PROJECT: HMCS CARLETON REPLACEMENT  
PROJET:

SUBJECT: ADDENDUM 1  
SUJET:

DWG NO.: SSK-234-01  
NUMÉRO DU DESSIN:

Drawing Number  
ADDN - 361 - 001

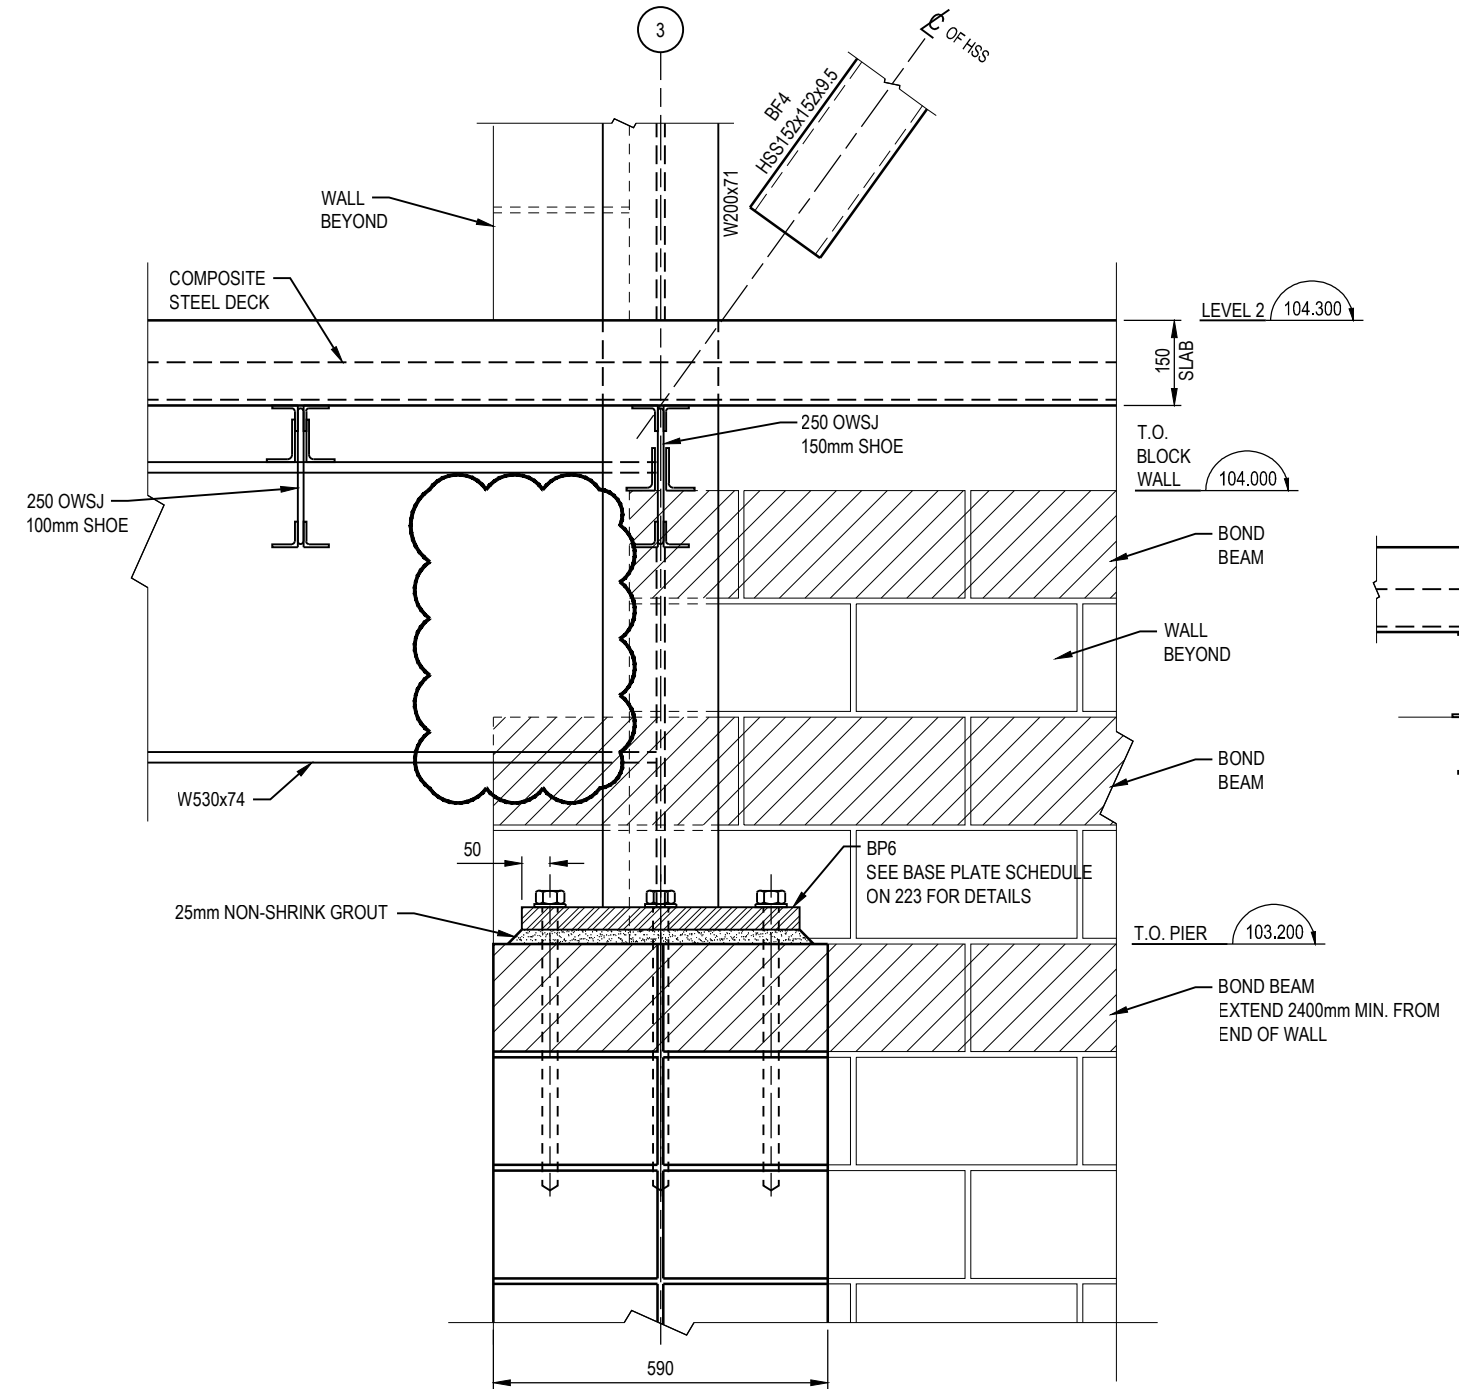
304 SECTION - CONCRETE BLOCK PIER  
212 SCALE: 1:10

303 SECTION - CONCRETE BLOCK PIER  
212 SCALE: 1:10

Drawing Description  
INTERIOR ELEVATIONS

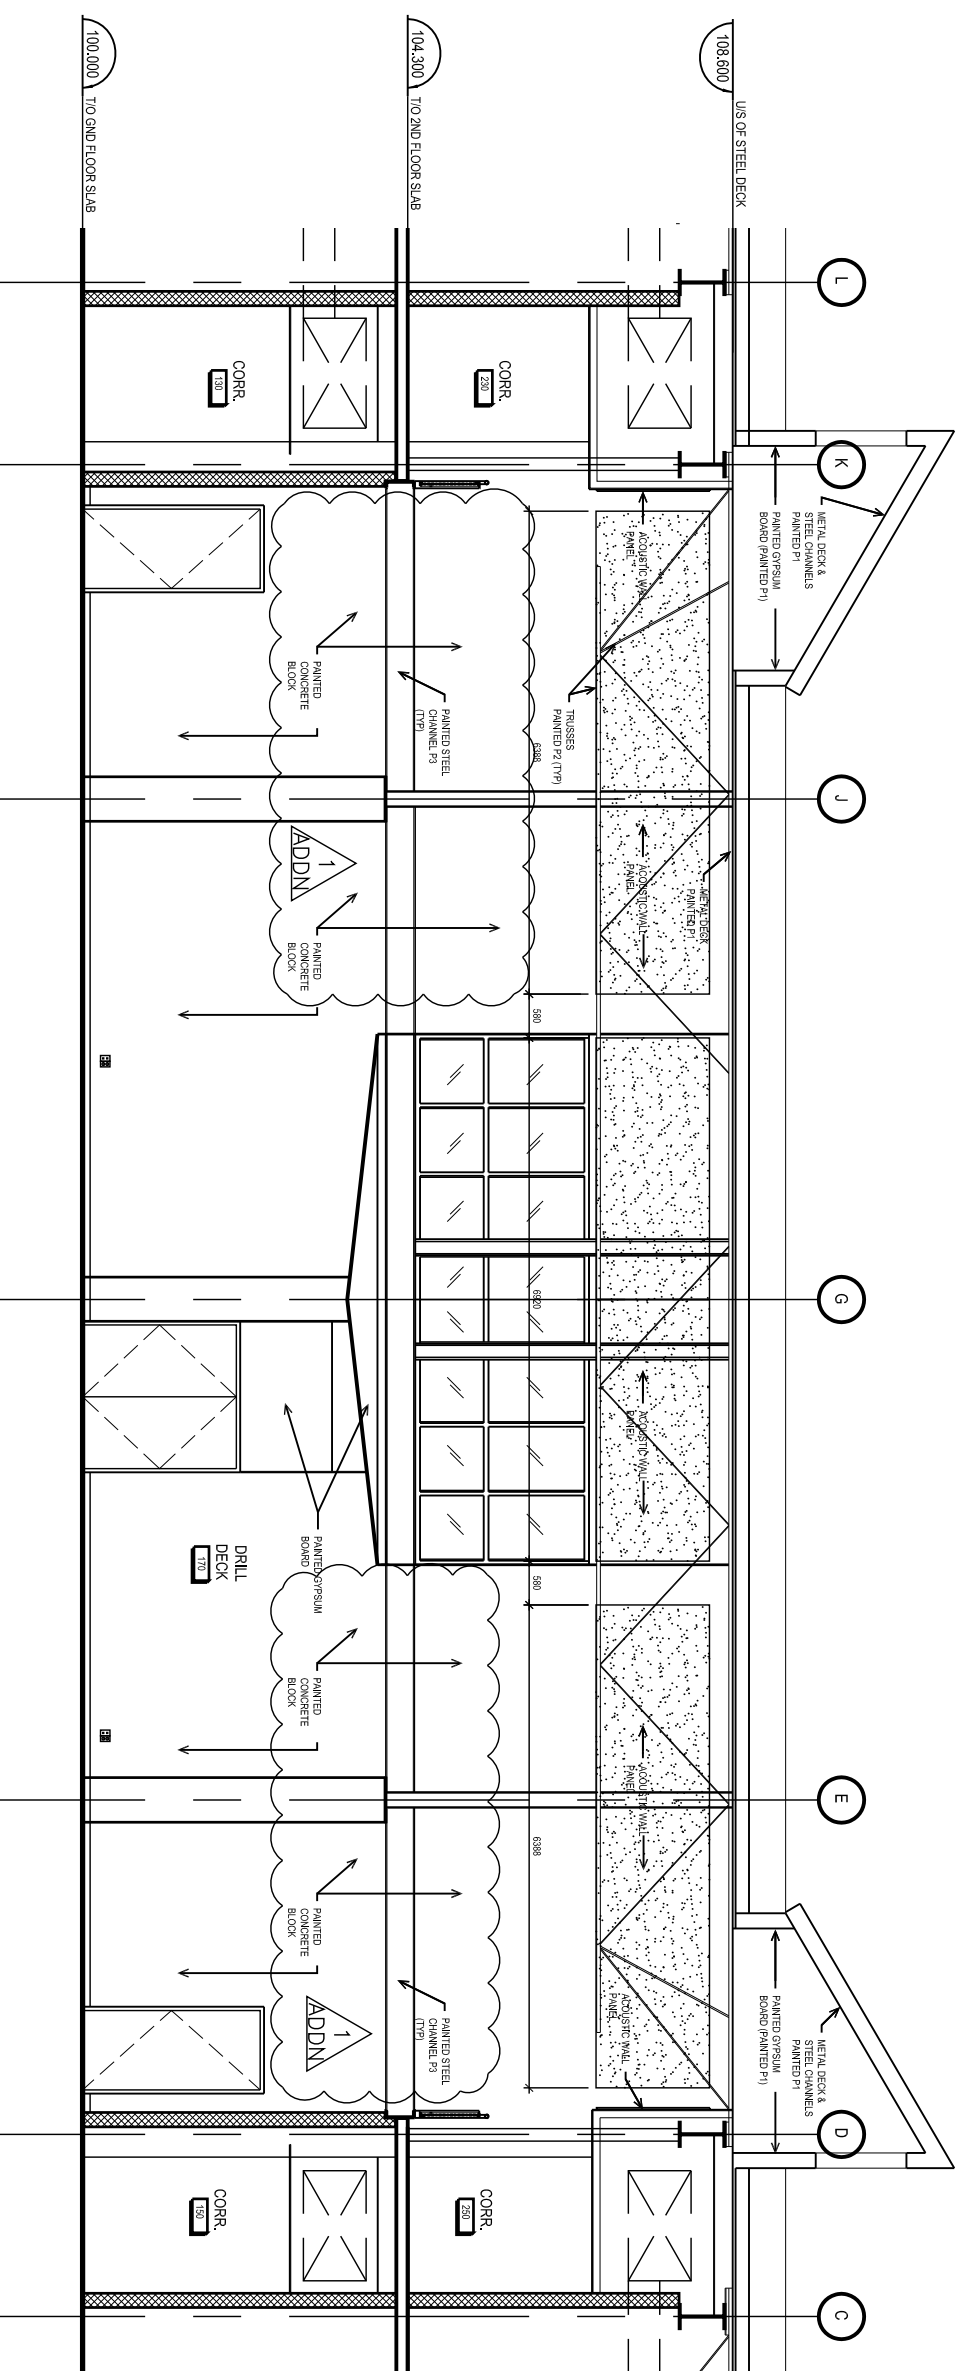
2 WALL SECTION (TYP) 1 ADDN. SCALE: 1:20

## ELEVATION - DRILL DECK
